MESA TOP DRIVE SOUTH BRIDGE

ELITE PROPERTIES of AMERICA, INC

REVIEW AND APPROVAL

Contech Superstructure Plans_r1.pdf Markup Summary

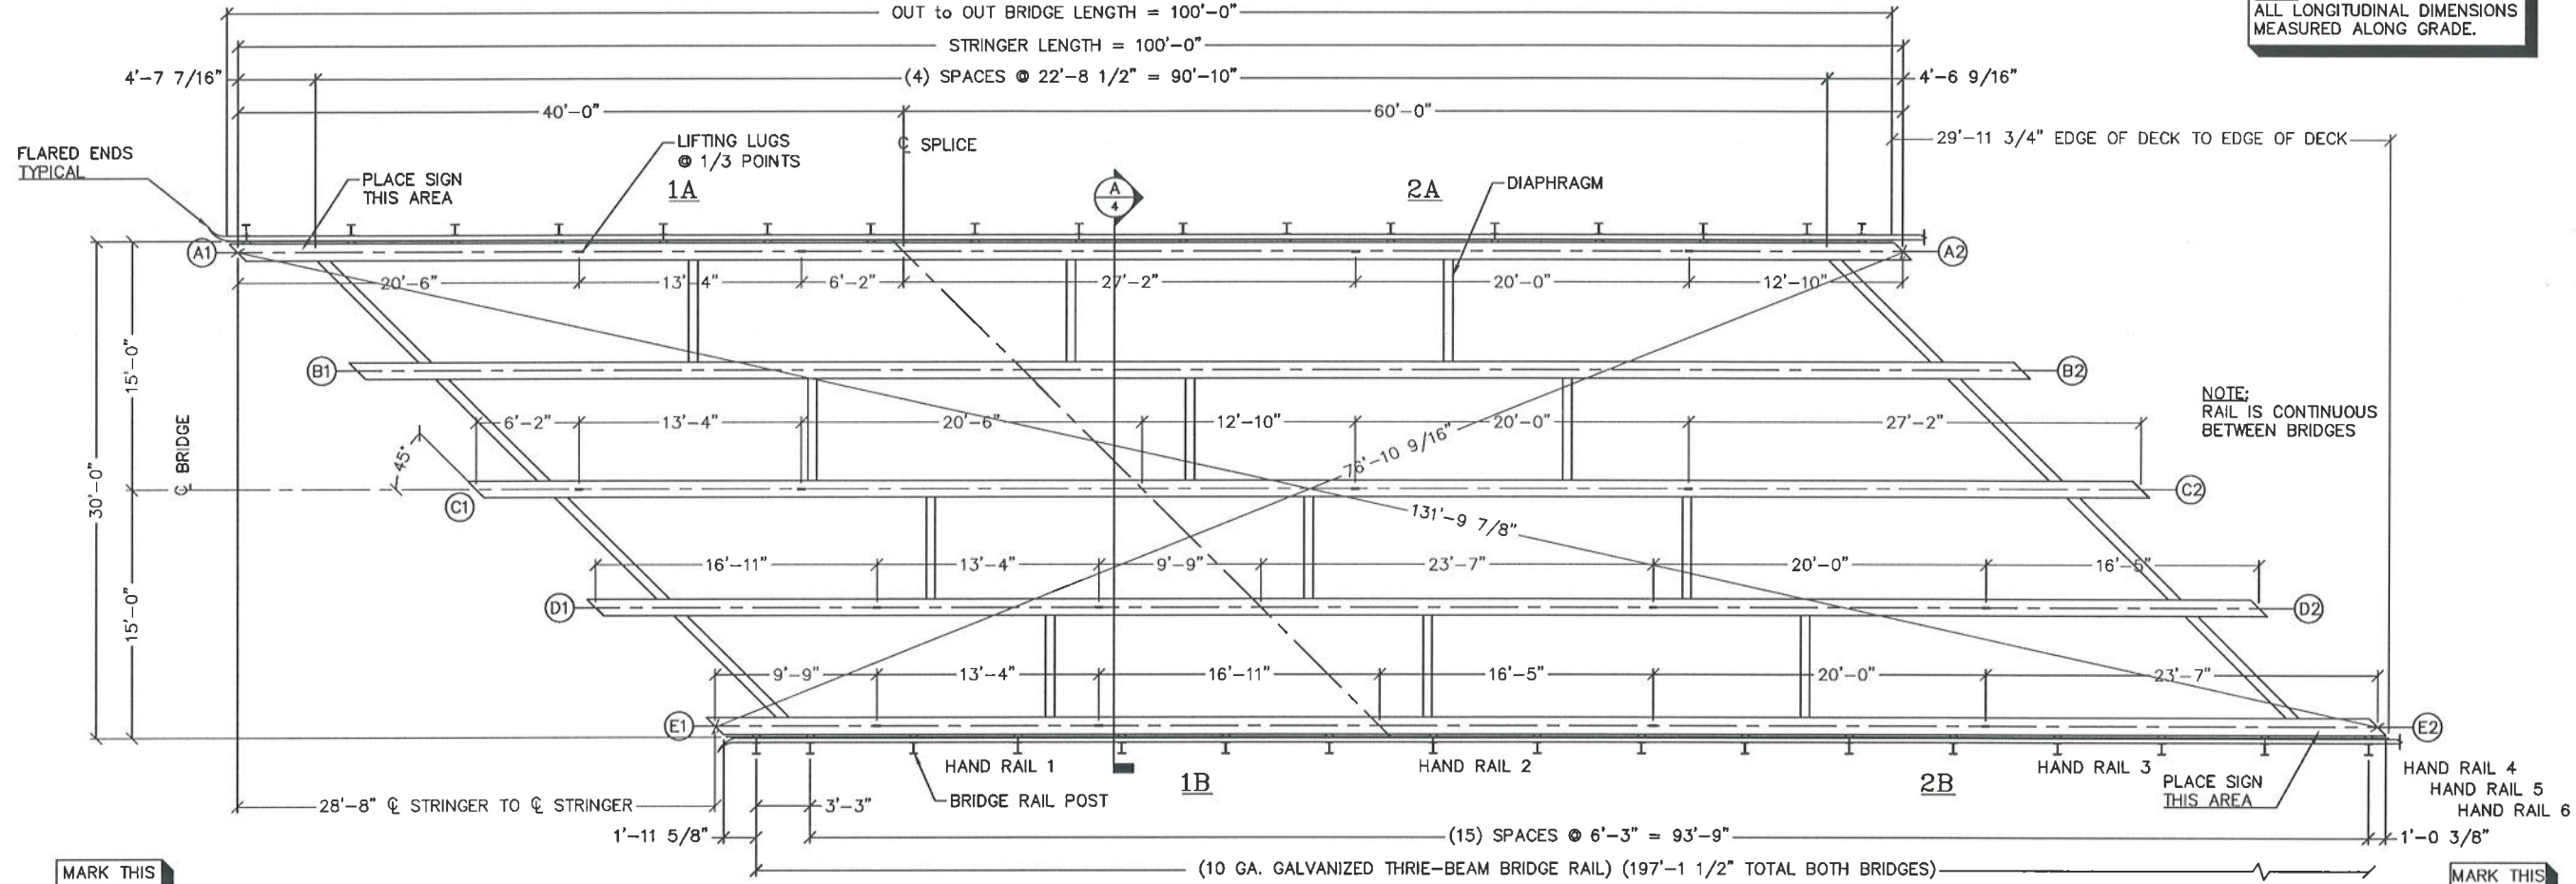
El Paso County, please make note.

Substructure Plans call out CDOT Concrete Class D, with an $f'c = 4500$ psi

Substructure plans call out CDOT Concrete Class D (Bridge)

Substructure plans call out epoxy rebar for deck.

FRAMING PLAN

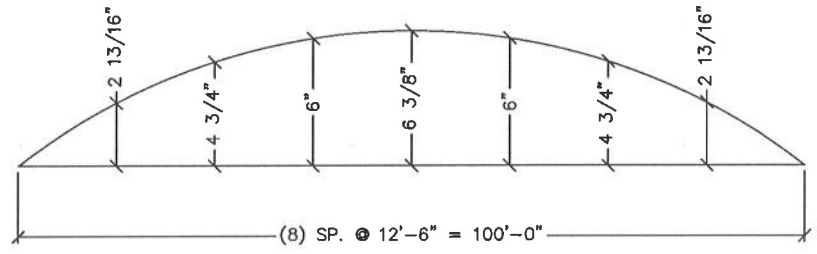
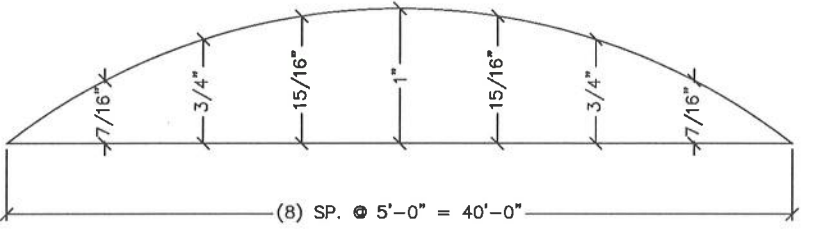
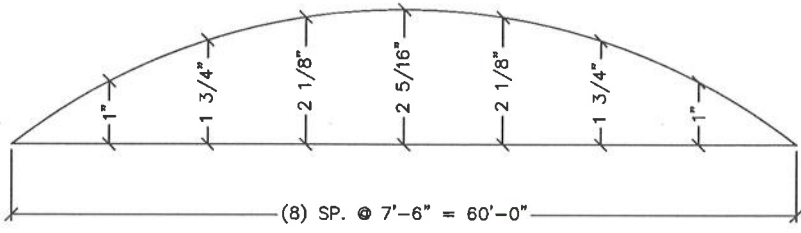
What is the specific girder size?

What is the specific girder size?

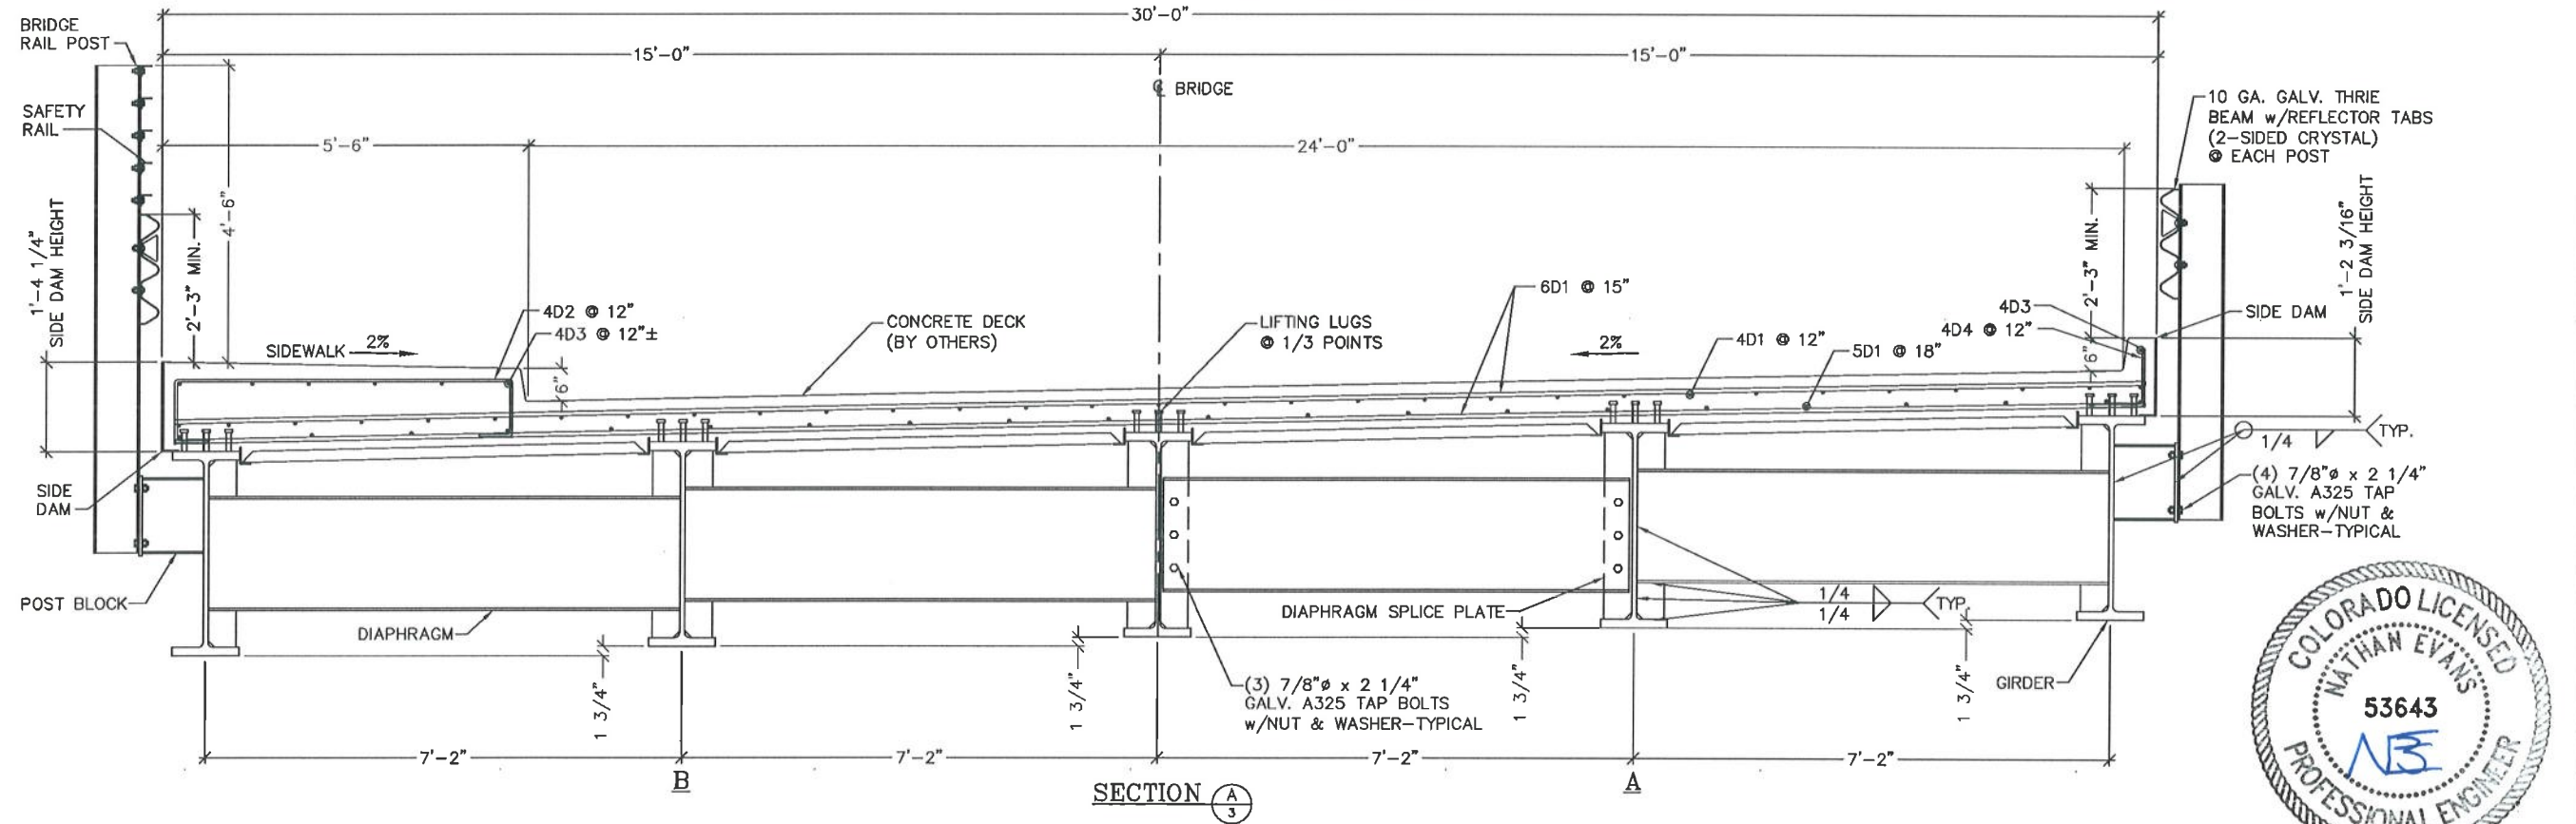
Spacing of reinforcing steel seems high. Would like to see deck design calculations.

Spacing of reinforcing steel seems high. Would like to see deck design calculations.
